# Historic Landmark Review Staff Report and Recommendation

**Request:** Window Replacement at the James T. Buxton (a.k.a. Moore) House

**File Number:** 311-18-000009-PLNG

**Property Location:** 2206 12<sup>th</sup> Avenue

2nd Floor North Bay (4)

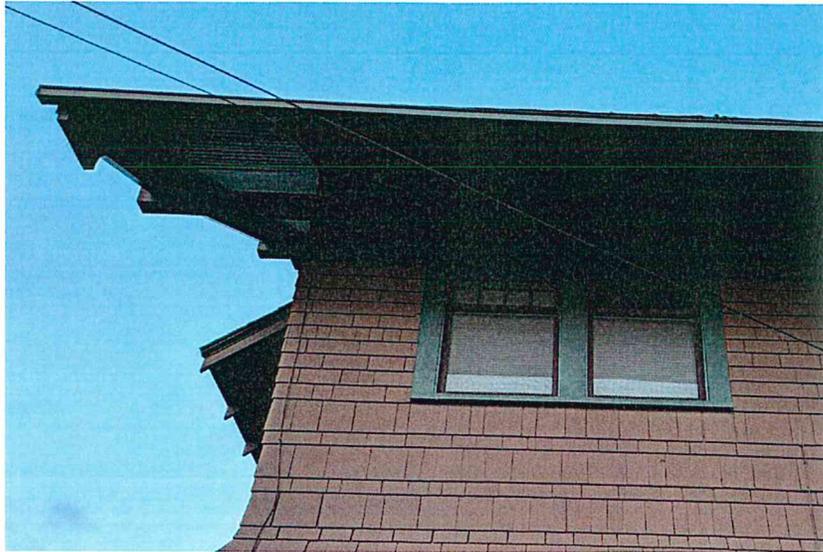
- *The leaded glass in a diamond pattern in one window may not be replicated; and*
- *The 16-over-1 window would be replaced with a 1-over-1 window in the second-story bay.*

- o *The leaded glass in a diamond pattern would not be replicated; and*
- o *The 16-over-1 window would be replaced with a 1-over-1 pane window in the second-story bay.*

Second Floor West Bay (3)

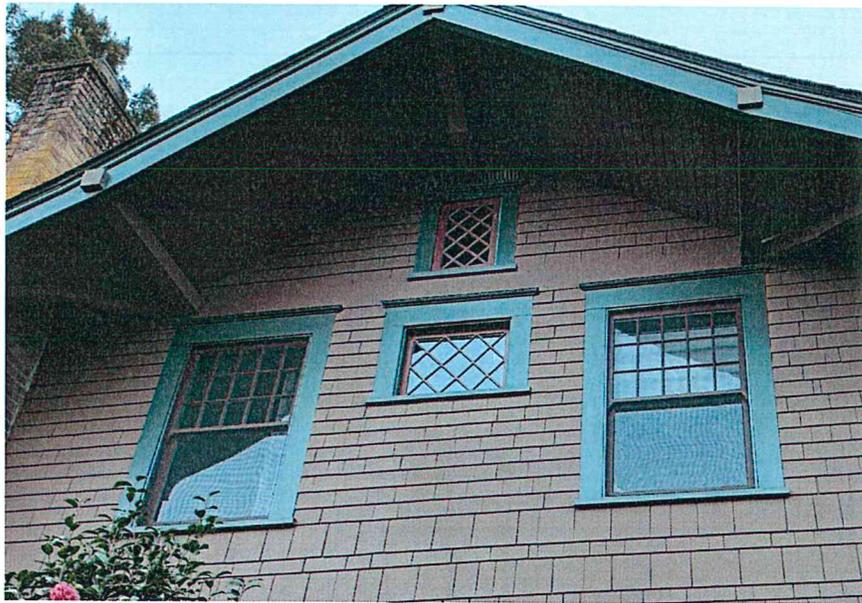
*Finding: Replacement windows would mostly replicate the existing windows, including true divided lights. The exceptions would be:*

# Like-for-Like Replacements

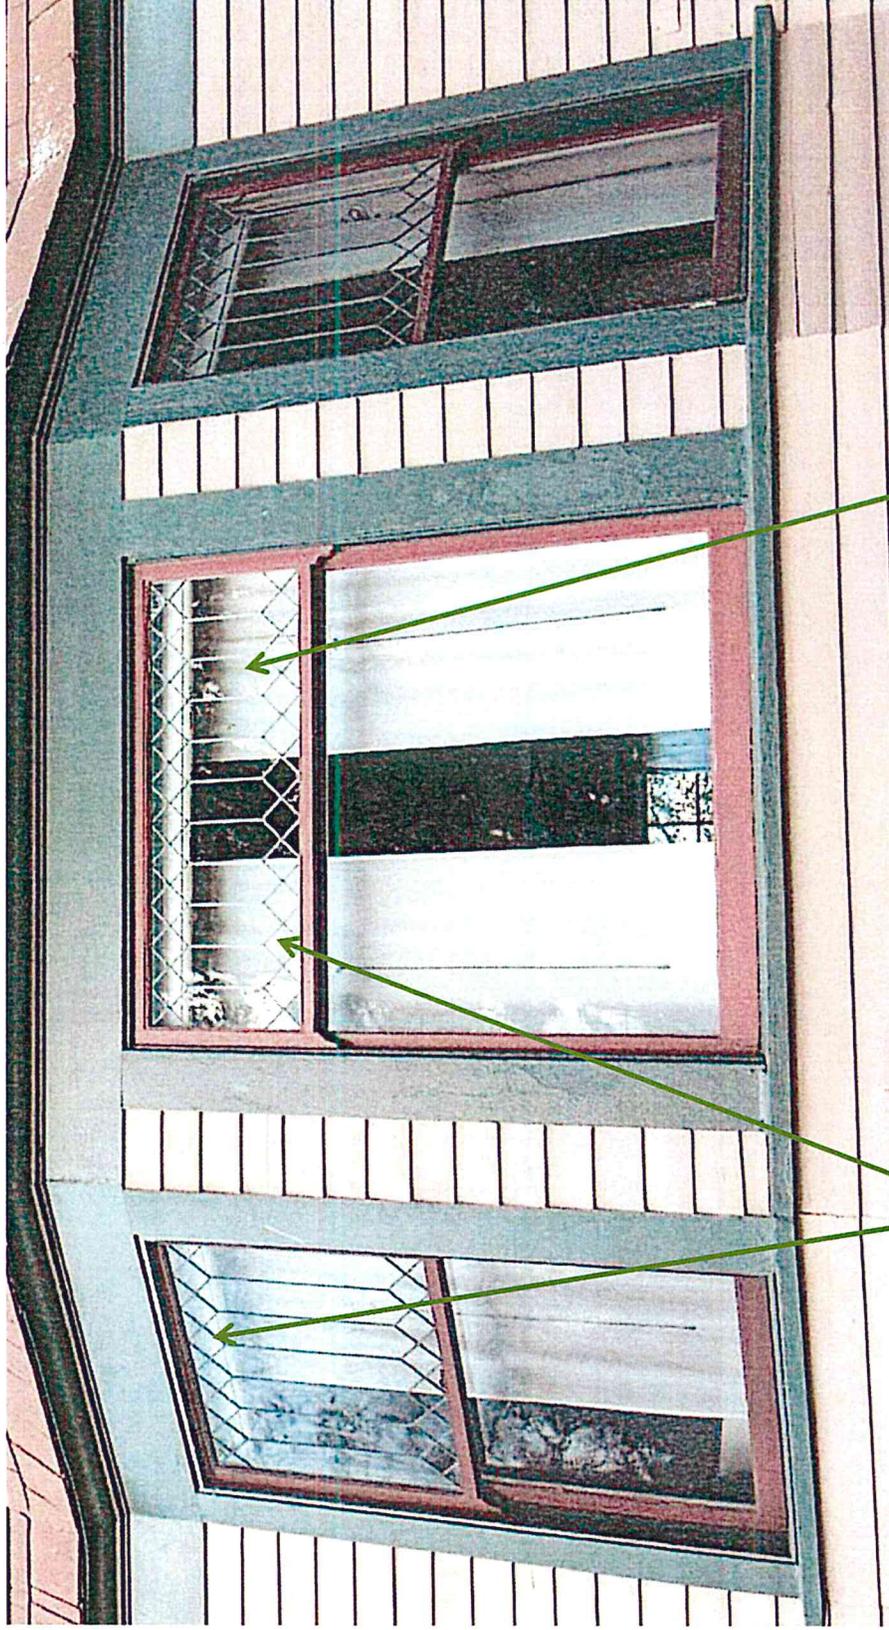
- The existing windows appear to be substantially intact and repairable.
- Even if they were replaced with exact duplicate windows (and several would not be replaced with exact duplicates), a portion of the James T. Buxton house's original, historic building fabric would be lost.
- For these reasons, staff recommends that the request to remove and replace the windows be denied.
